Environmental Control and Protection - Planning Consultation Response

Planning Application Reference:	PL/2023/10495
Environmental Health Reference:	WK/202328891
Description of Proposal:	Conversion of Elmfield House and outbuildings to 6 x dwellings and the erection of 15 dwellings, hard and soft landscaping and associated works
Address:	Elmfield Cottage, Petersfinger Road, Petersfinger, Salisbury, Wiltshire, SP5 3BZ
Amenity Including noise, lighting, odour, smoke.	
I am writing regarding planning application PL/2023/10495 for Conversion of Elmfield House and outbuildings to 6 x dwellings and the erection of 15 dwellings, hard and soft landscaping and associated works. <u>Noise</u> I am aware there is existing planning permission for part of the site but I do not believe we have agreed to discharge of the condition relating to design and noise. A Noise Impact Assessment has been submitted which includes measurements of ambient sound levels taken between 14th and 19th September 2023. The site is adjacent to the busy A36 where there is frequent traffic congestion. As expected the measurements shown in table 1 section 4.7 of the report indicate the site is high risk from noise if a Pr

Title:
Daytime (07:00-23:00) Noise Contours, dB
 $L_{Aeq, 16 hr}$

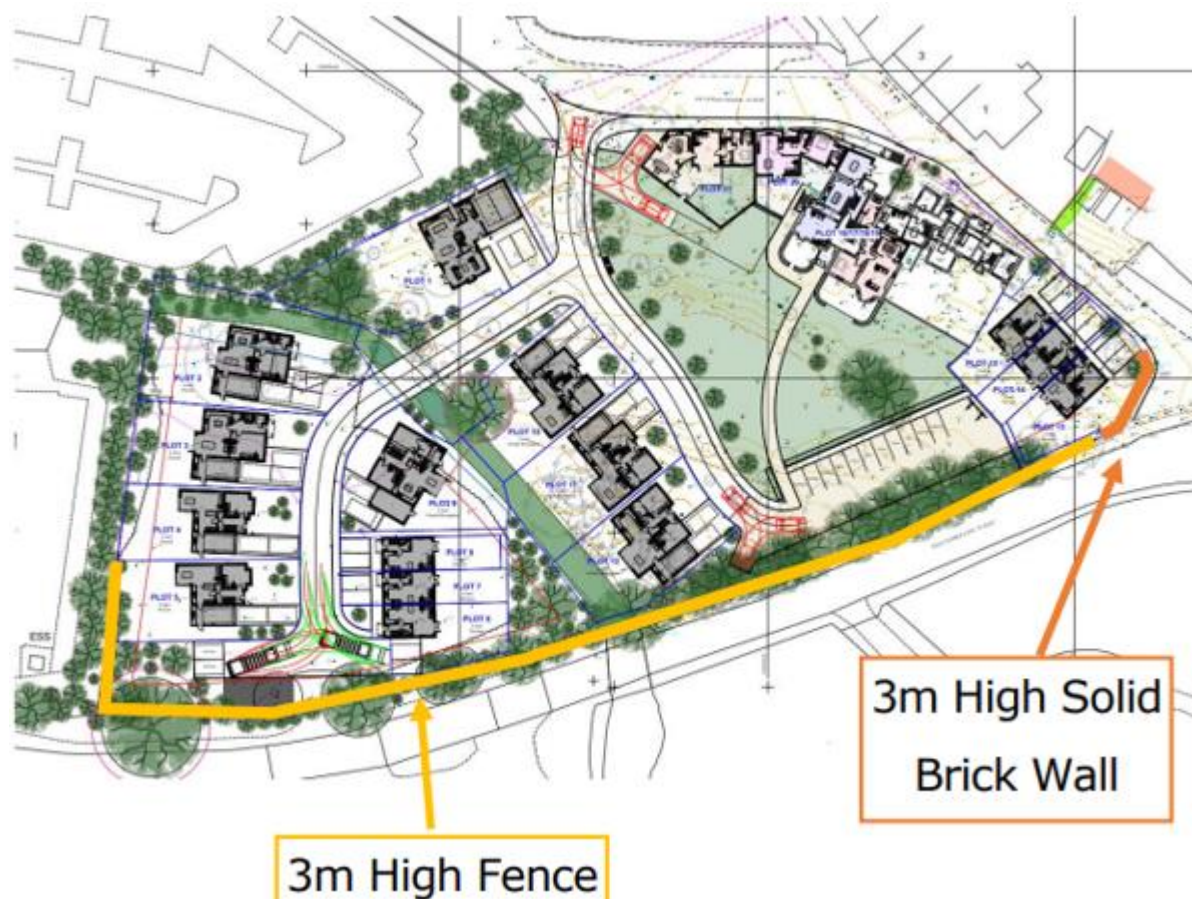
Unfortunately the density of housing results in dwellings being close to the road and residents of some of the properties would need to keep their windows closed all of the time (except for purge ventilation) so that suitable internal noise levels achieved. The diagram below, taken from the submitted report indicates the 9 dwellings where improved glazing and ventilation will be required and windows kept closed. If this application was to be approved these dwelling would need to be provided with mechanical ventilation, trickle vents as described in the noise impact assessment would not be sufficient.

I am not sure why Zone V1 is livingrooms and bedrooms and Zone V2 is bedrooms only as it appears all 9 properties are subject to noise levels above 50dB LAeq 16hours in the daytime. An open window would provide a maximum of 15dB attenuation so above 50dB externally would mean living room noise levels with windows open would be above 35dB LAeq16hours recommended in BS8233 and by the World Health Organisation
